Access Compliance Report Public Rights-of-Way (Curb Ramps)

Main Street: ISLAND_WAY		Cross Street: DANA_POINT_HARBOR_DR		Location:	S
ADA ID: RPRK220208173039	Ramp Type:Type 1 - Perpendicular	Initial Pass/Fail: Fail	Overall Compliance: No	Severity Score:	30

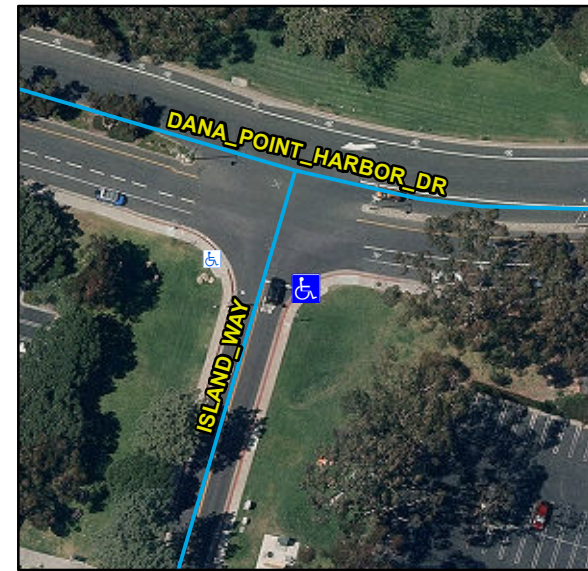
R204.3, R304.2.2, STD 1115

Compliance	Description	Data	Compliance	Description	Data
N/A	Ramp Length (in)	70	N/A	Flare Type LT	
Yes	Ramp Width (in)	48			N/A
No	Ramp Run Slope (%)	17.4	N/A	Flare Slope LT (%)	N/A
Yes	Ramp Cross Slope (%)	0.8	N/A	Flare Traversable LT	N/A
N/A	Landing Present	N/A	N/A	Flare Type RT	
N/A	Landing Length (in)	N/A			N/A
N/A	Landing Width (in)	N/A	N/A	Flare Slope RT (%)	N/A
N/A	Landing Run Slope (%)	N/A	N/A	Flare Traversable RT	N/A
N/A	Landing Cross Slope (%)	N/A	N/A	DWS Provided	N/A
N/A	Landing Movement Obstructed?	N/A	N/A	DWS Contrast	N/A
	Landing Movement Type	N/A	N/A	DWS Length (in)	N/A
N/A	Landing Shared	N/A	N/A	DWS Full Width	N/A
N/A	Clear Space	N/A	N/A	DWS Offset Left (in)	N/A
N/A	Clear Space To Crosswalk (in)	N/A	N/A	DWS Offset Right (in)	N/A
N/A	Marked Crosswalk 1	No	N/A	Marked Crosswalk 2	N/A
	Crossing 1 Direction	NW		Crossing 2 Direction	N/A
	Marked Crosswalk 1 Width (in)	N/A		Marked Crosswalk 2 Width (in)	N/A

Remove & Replace Entire Ramp.
